**Response to NRC
Comments
on
*Assessment Report for
Well 1319 Area***

**Cimarron Corporation's Former
Nuclear Fuel Fabrication Facility
Crescent, Oklahoma**

**License Number: SNM-928
Docket Number: 70-0925**

Re: Docket No. 70-925; License No. SNM-928
Response to NRC Comments on Assessment Report for Well 1319 Area

ATTACHMENT 4

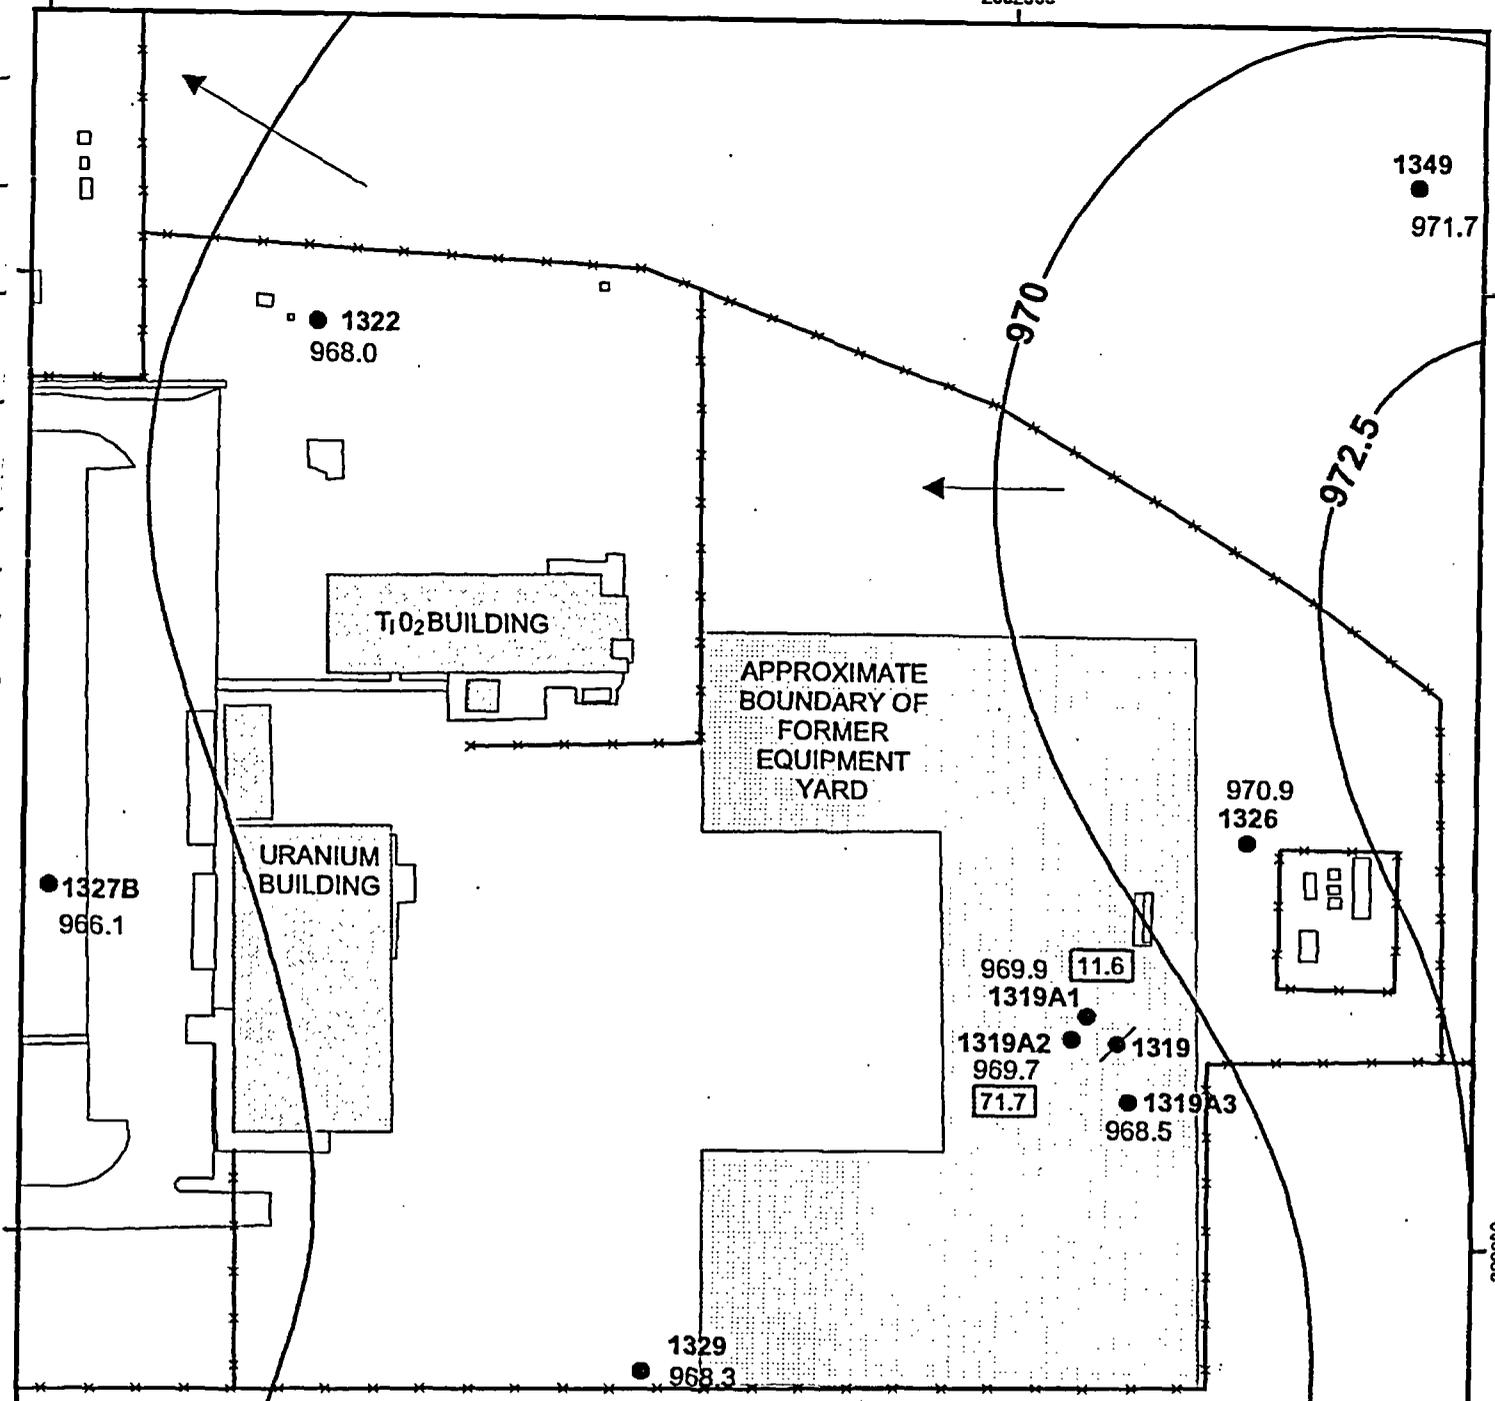
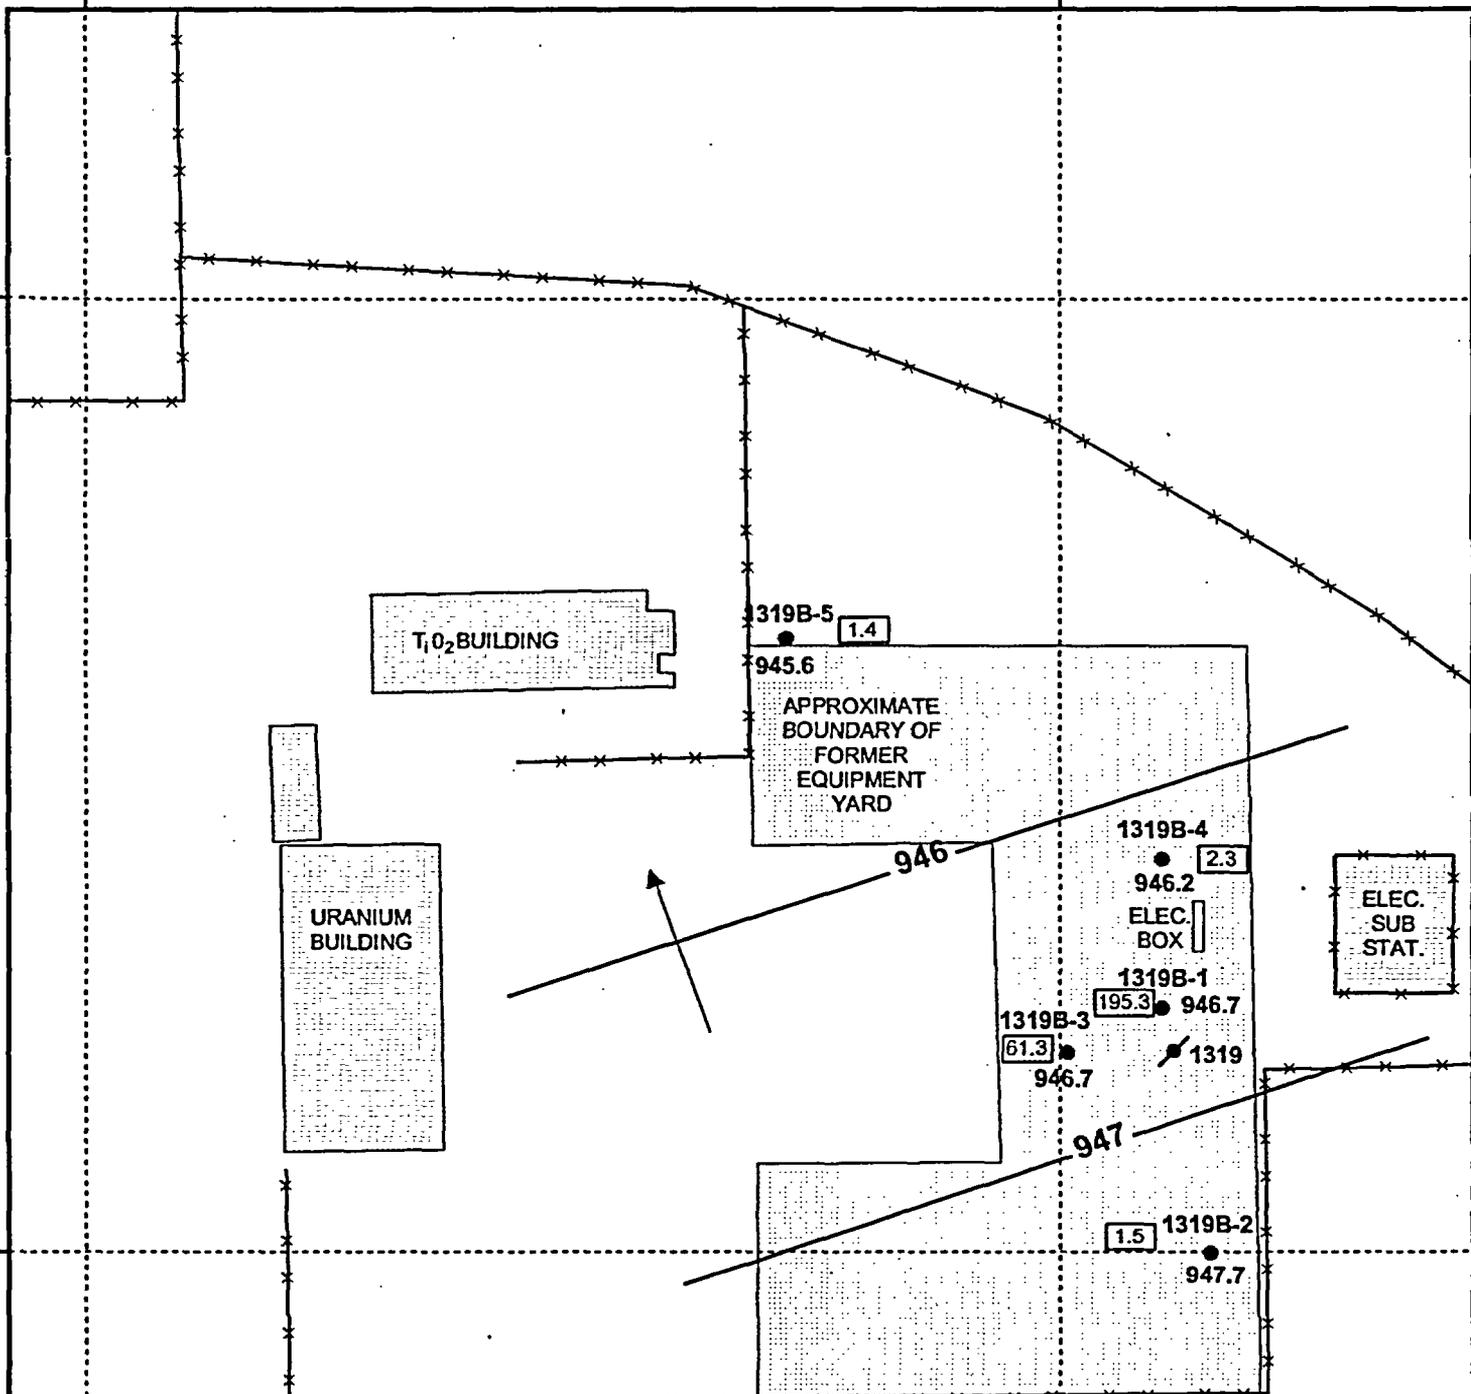
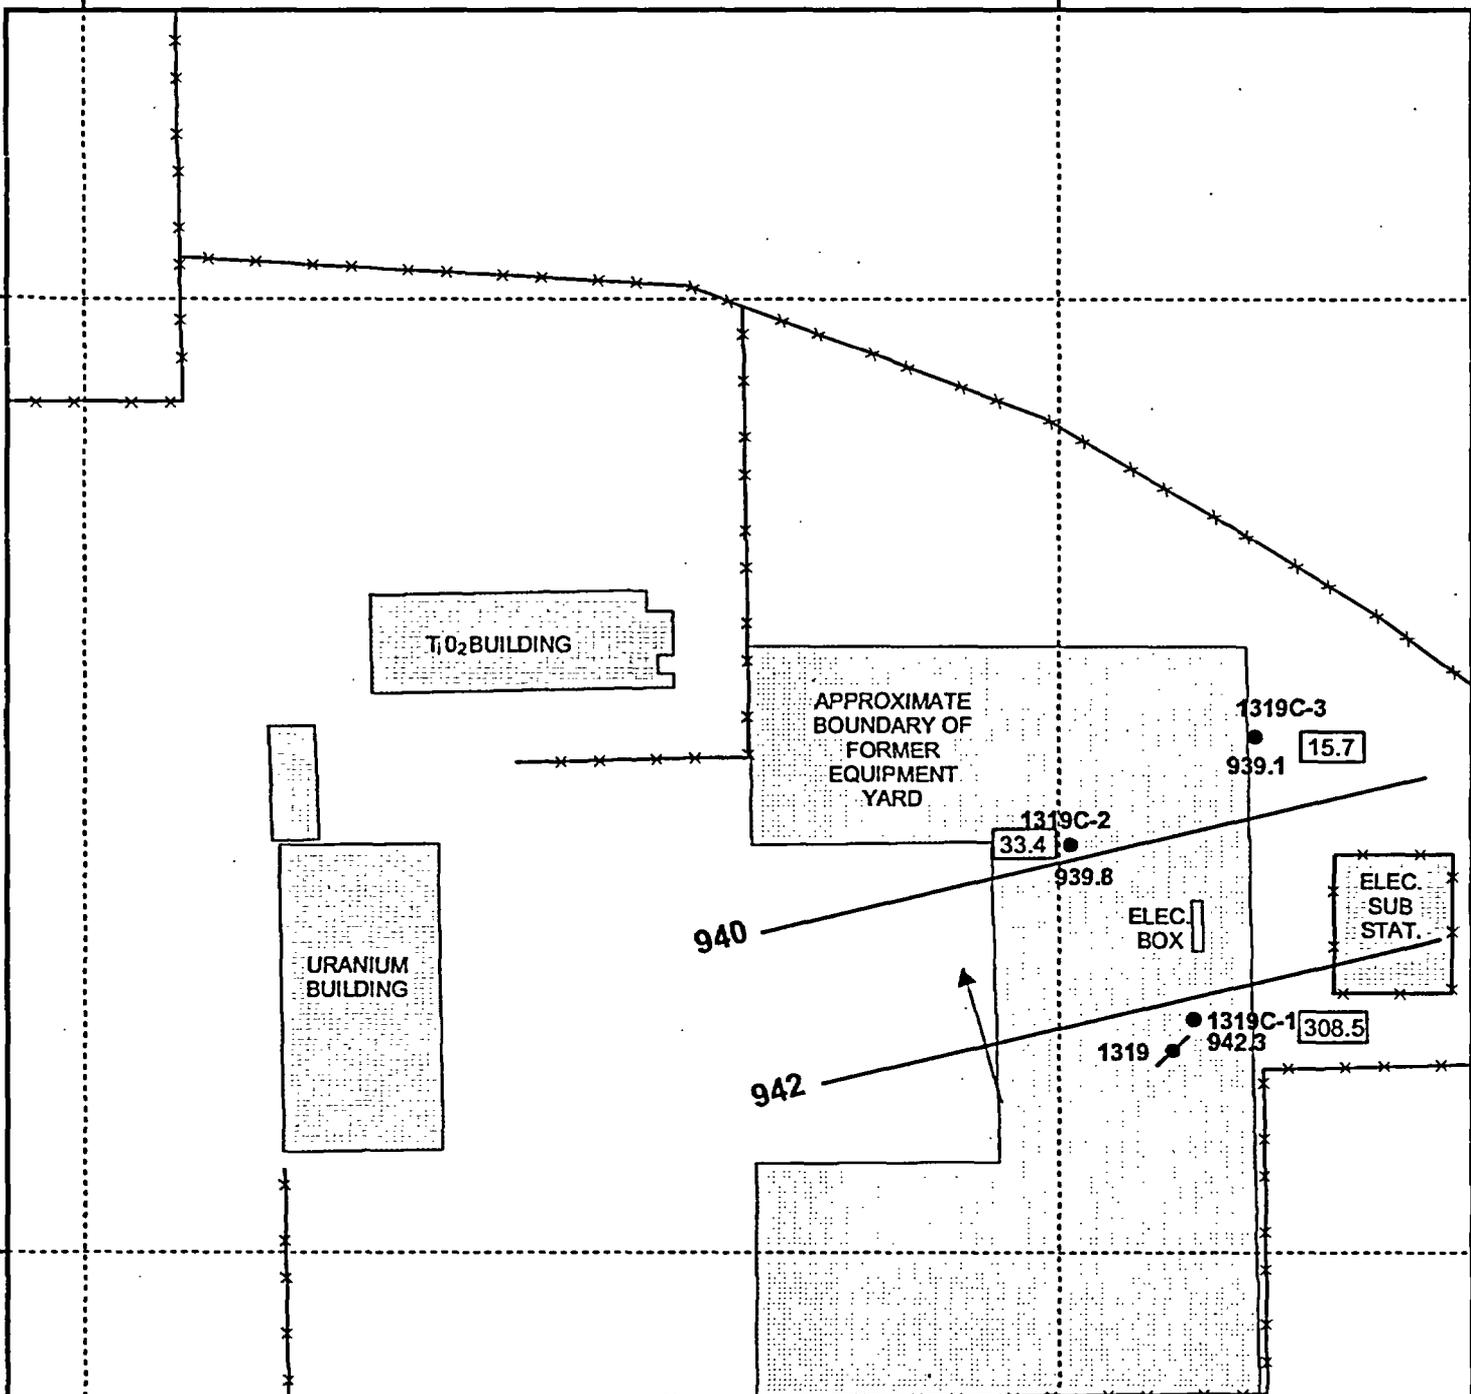
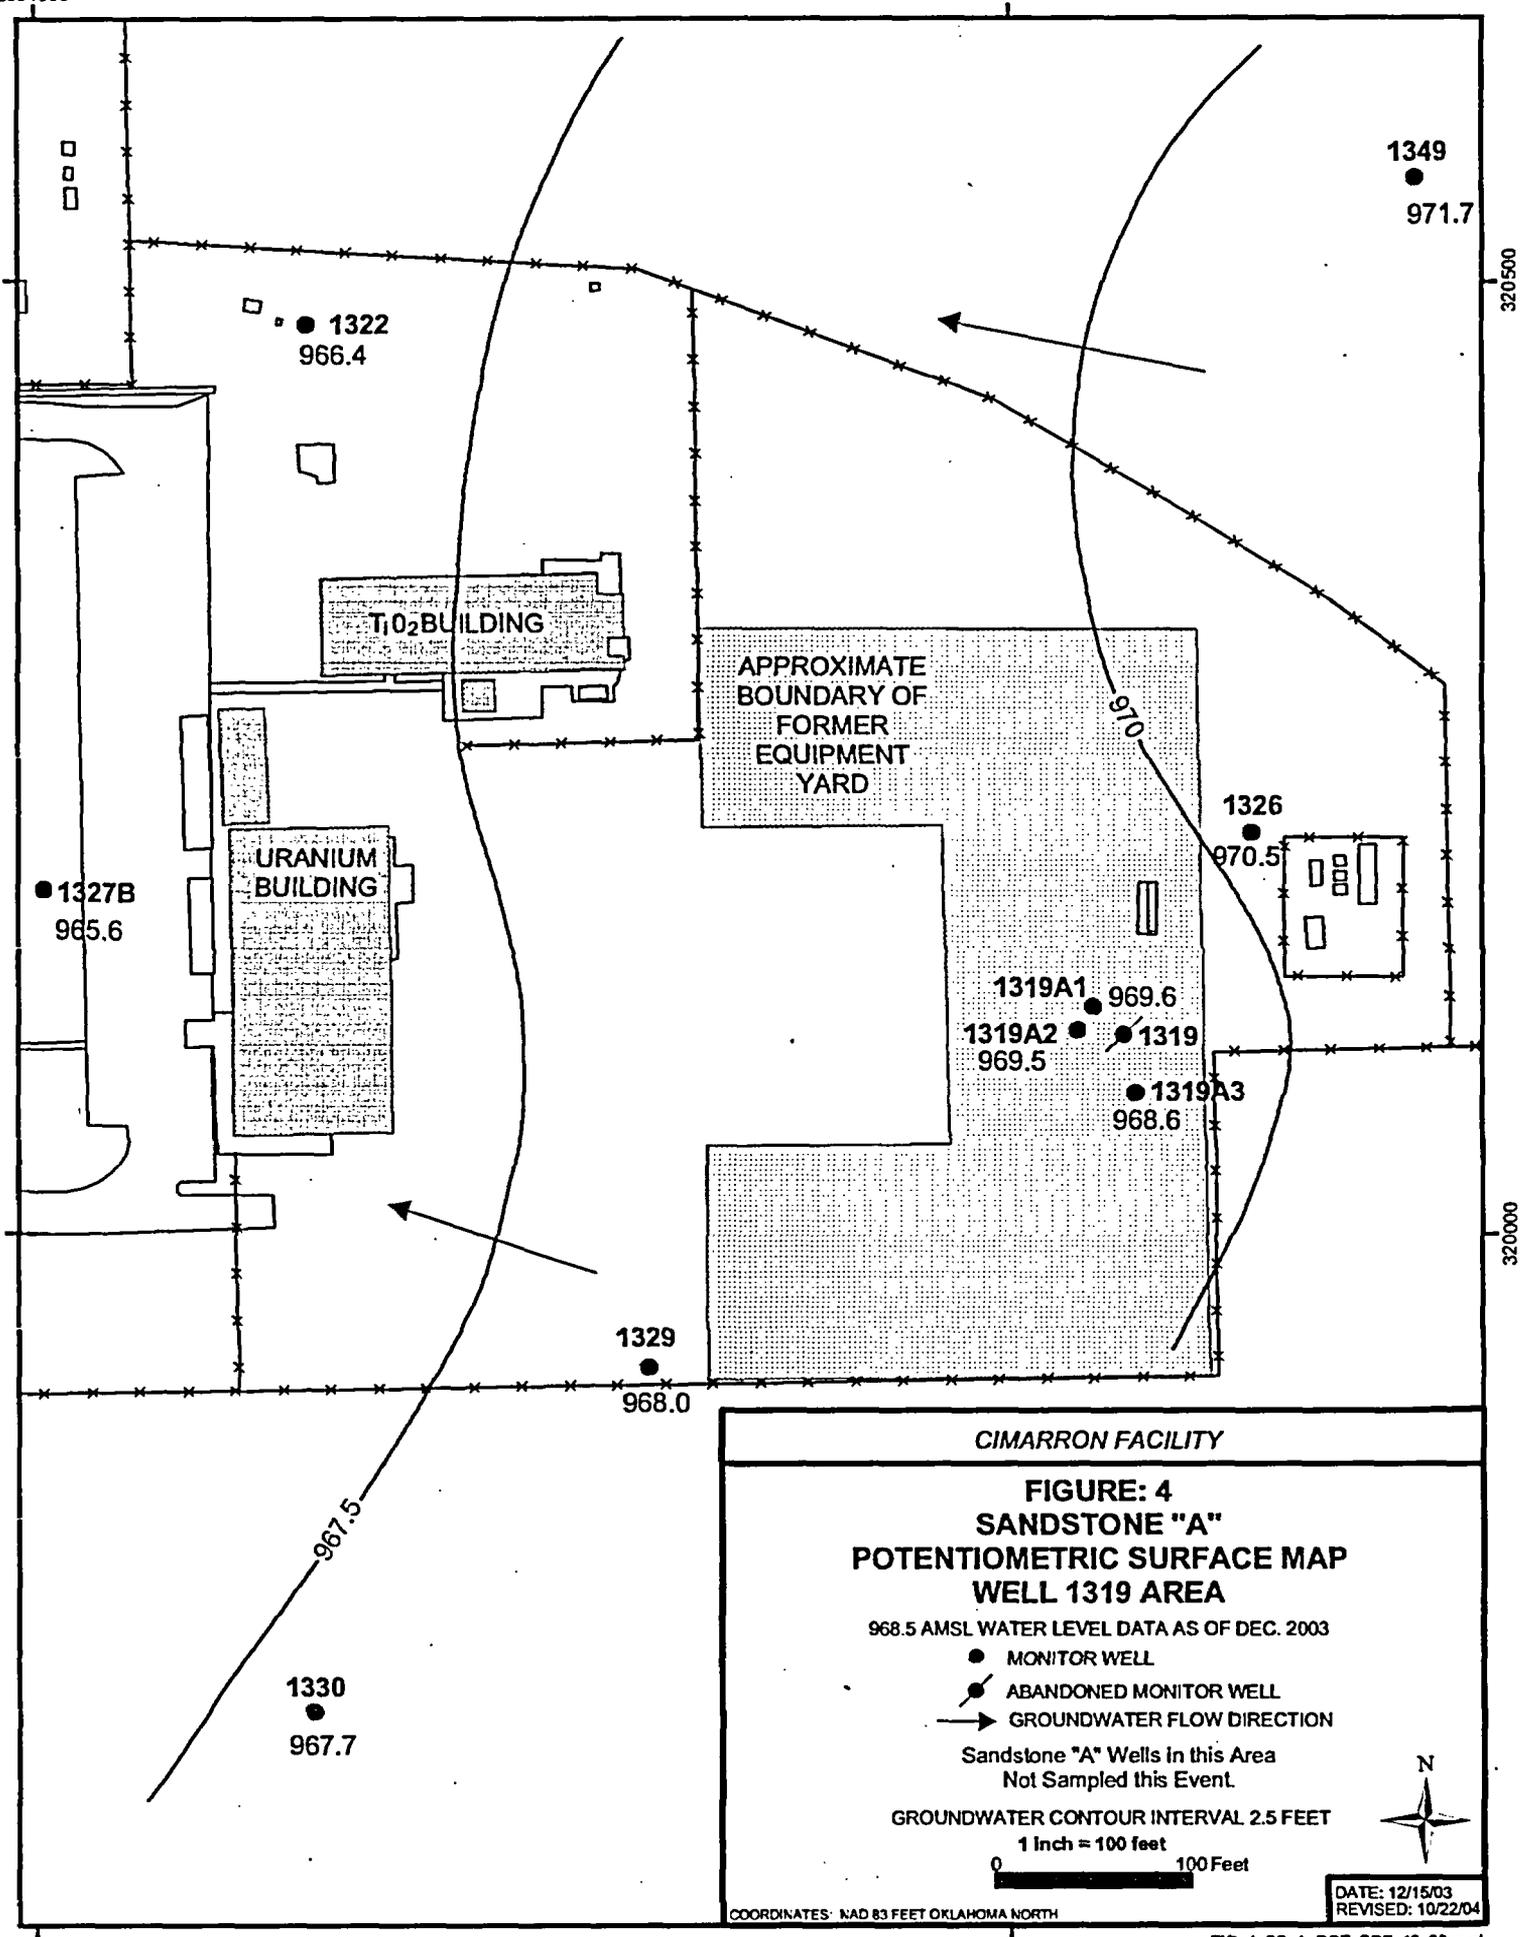
The licensee should provide additional water levels, groundwater flow directions, and total uranium analytical results since the September 2003 sampling event.

Cimarron provided potentiometric surface maps in Figures 8, 9, and 10 for Sandstones A, B, and C, respectively, in "Assessment Report for Well 1319 Area". Those maps have been updated to include total uranium concentration for the September 2003 sampling event. Groundwater elevations were recorded for wells in the Well 1319 area during the December 2003, May 2004, and August 2004 sampling events. Sets of similar figures were created for each of these three events, presenting the potentiometric surface and groundwater flow directions for each of the three sandstone units. Total uranium concentrations are not shown on all figures because only Wells 1319B-1 and 1319C-1 were sampled during some events. Most of the wells in the area were sampled during the August 2004 sampling event, so figures for that event include total uranium concentrations for all wells in the Well 1319 Area that were sampled. These figures are included in this submittal as Attachment 4.
